Docket No. 50-321

The Commission has issued the enclosed Amendment No. 52 to Facility Operating License No. DPR-57 for the Edwin I. Hatch Nuclear Plant Unit No. 1. The amendment consists of changes to the Technical Specifications in response to your request of August 26, 1977 as supplemented December 1, 1977, January 5, February 22 and March 8 and 16, 1978.

EDWIN I. HATCH NUCLEAR PLANT UNIT NO. 1

EDWIN I. HATCH NUCLEAR PLANT UNIT NO. 1
RELOAD 2
SAFETY EVALUATION REPORT

FIGURE 3.11-1 (SHEET 1)

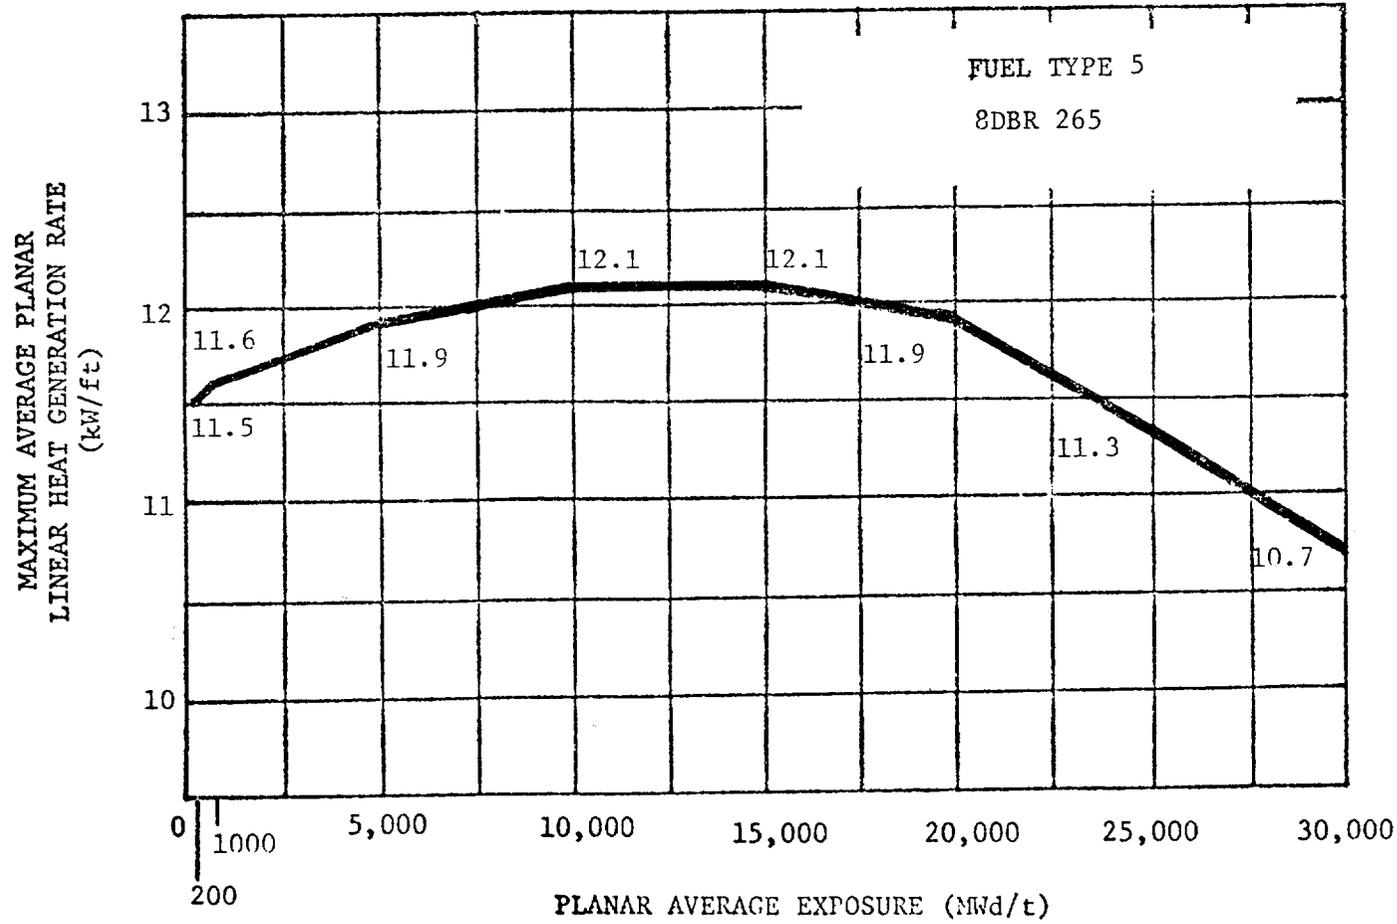
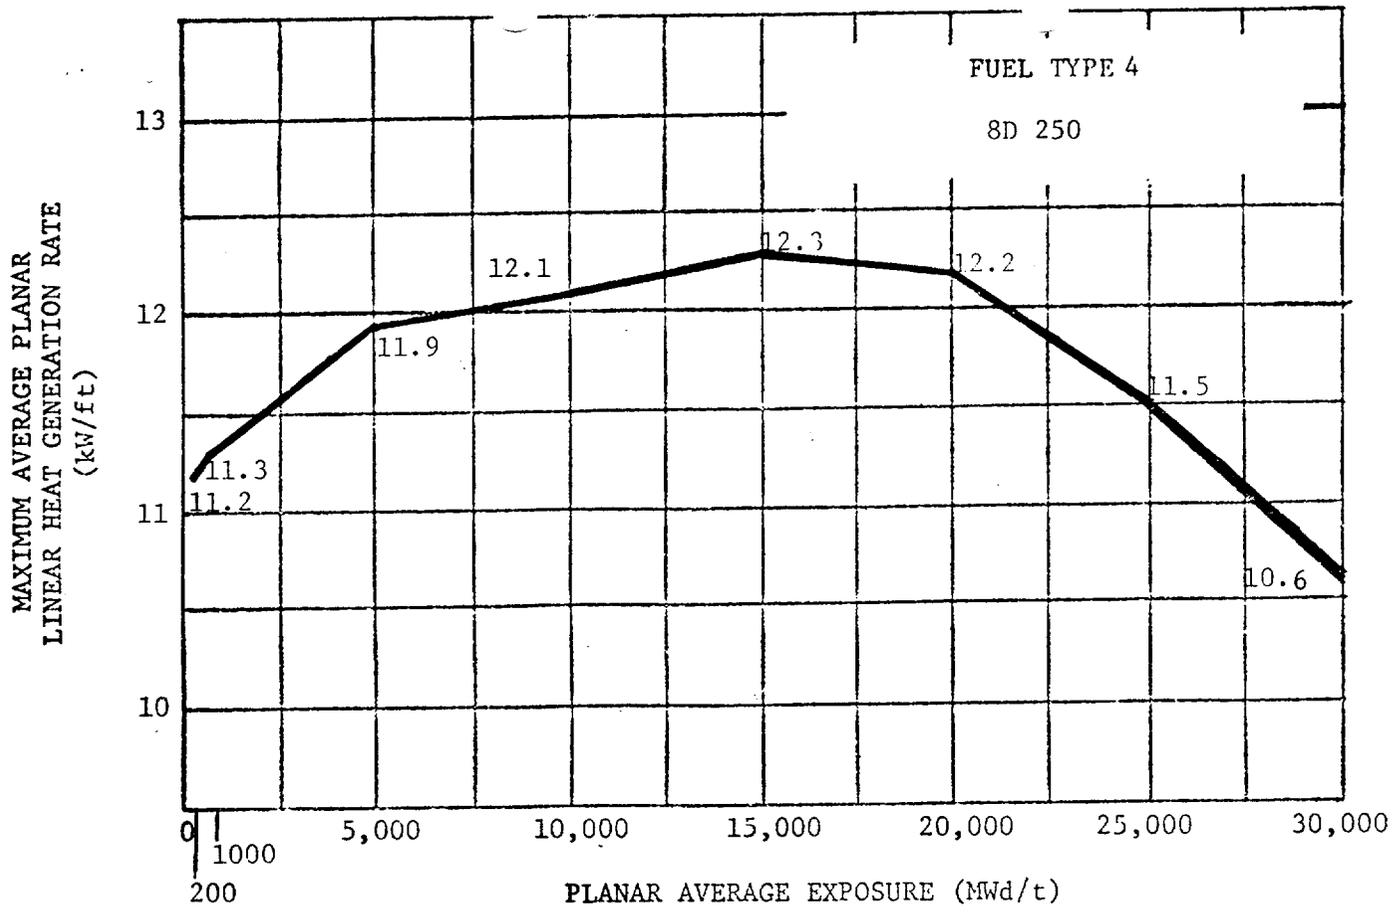
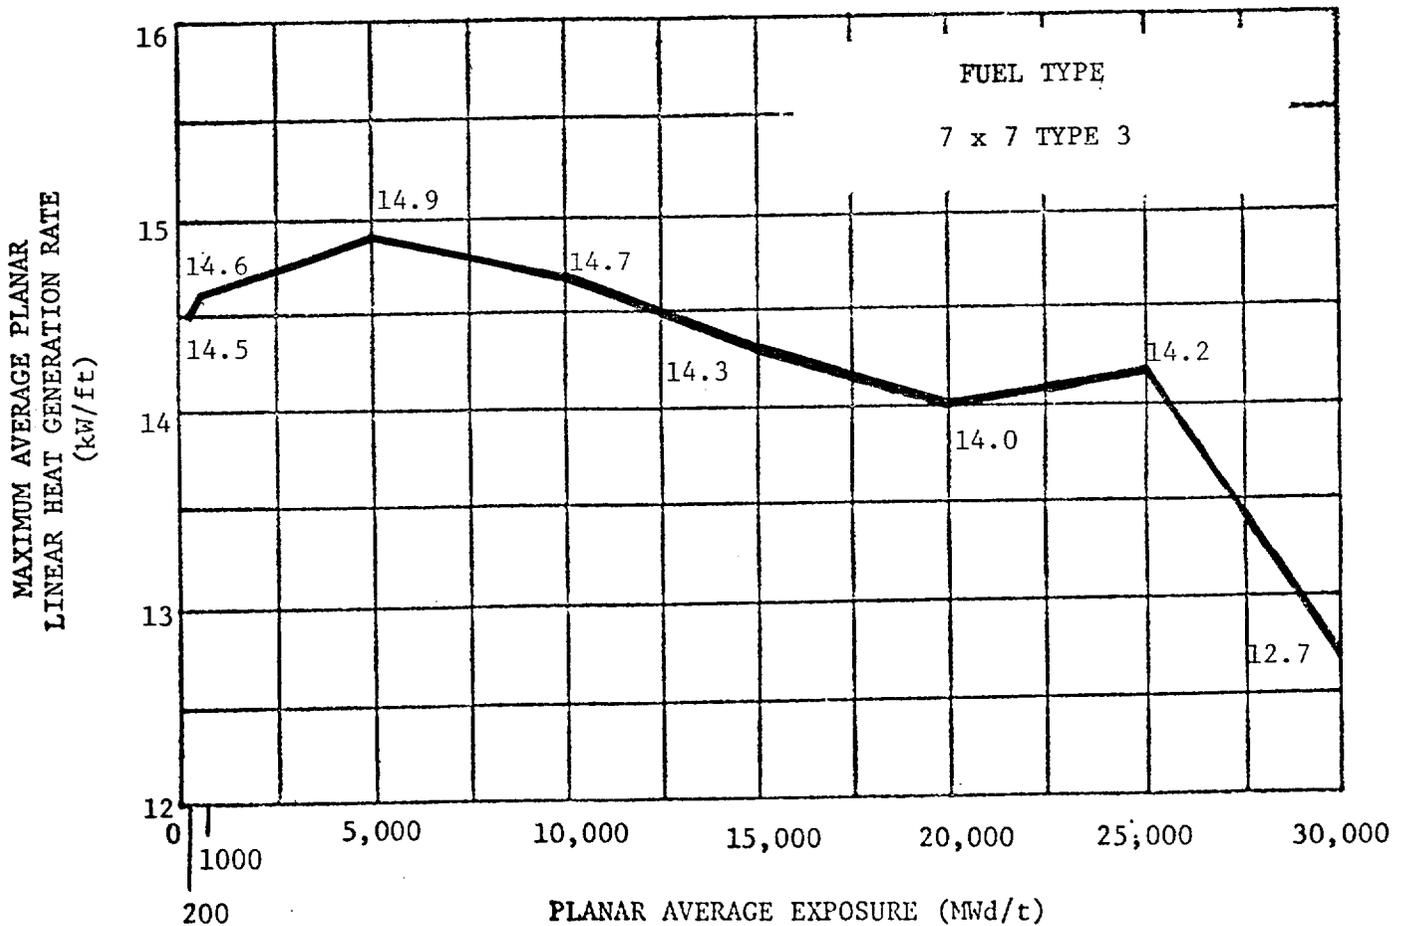
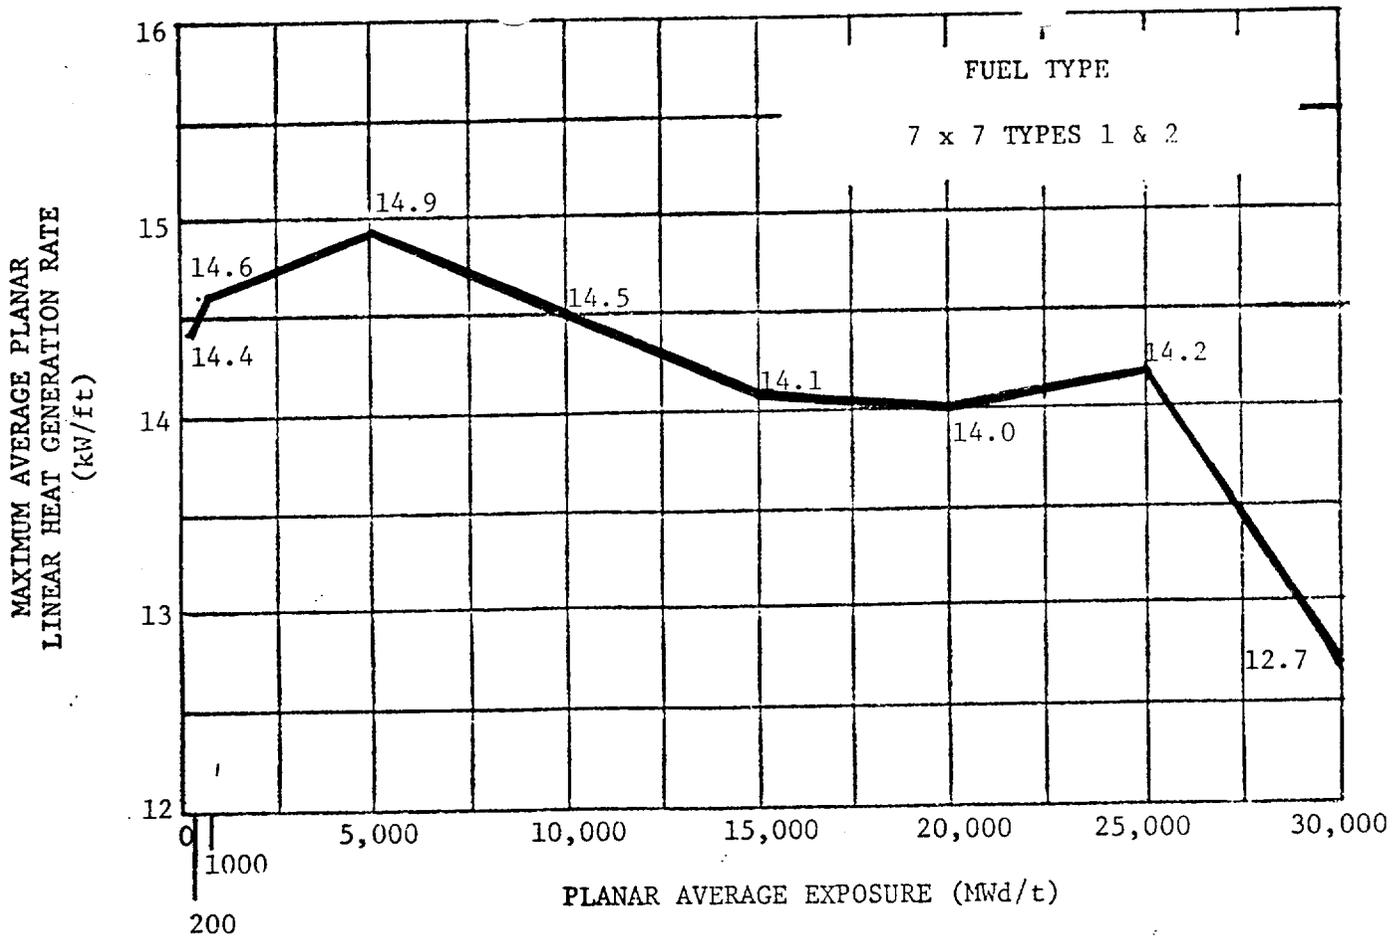
During power operation, the APLHGR for each type of fuel as a function of average planar exposure shall not exceed the limiting value shown in Figure 3.11-1, sheets 1 and 2. If at any time during operation it is determined by normal surveillance that the limiting value for APLHGR is being exceeded, action shall be initiated within 15 minutes to restore operation to within the prescribed limits. If the APLHGR is not returned to within the prescribed limits within two (2) hours, then reduce reactor power to less than 25% of rated thermal power within the next four (4) hours. If the limiting condition for operation is restored prior to expiration of the specified time interval, then further progression to less than 25% of rated thermal power is not required.

Thus, based on our review of the applicability of the ECCS-LOCA models to the 8x8R fuel type, the corrected analyses⁽⁴⁾ and the lead plant analysis, we conclude that Hatch-1 will be in conformance with all requirements of 10 CFR 50.46 and Appendix K to 10 CFR 50.46 when operated in accordance with the MAPLHGR versus Planar Average Exposure curves given in Figure 3.11-1, sheets 1 and 2, of the proposed Technical Specifications⁽⁵⁾.

The licensee has also proposed changes and additions⁽⁵⁾ to the MAPLHGR vs. planar average exposure curves currently appearing in the Hatch-1 Technical Specifications. Our evaluation of the proposed curves is discussed in Section 3.5.1. The MAPLHGR changes for the 7x7 and standard 8x8 fuel types reflect the results of revised LOCA calculations, performed to correct all of the GE input errors, made in connection with the previous LOCA analysis. An additional MAPLHGR curve, based on corrected inputs for the reload 8x8R fuel is also provided. Based on our evaluation of the information provided, the staff finds the proposed new MAPLHGR vs. planar average exposure curves appearing in Figure 3.11-1 of Reference 4 to be acceptable.
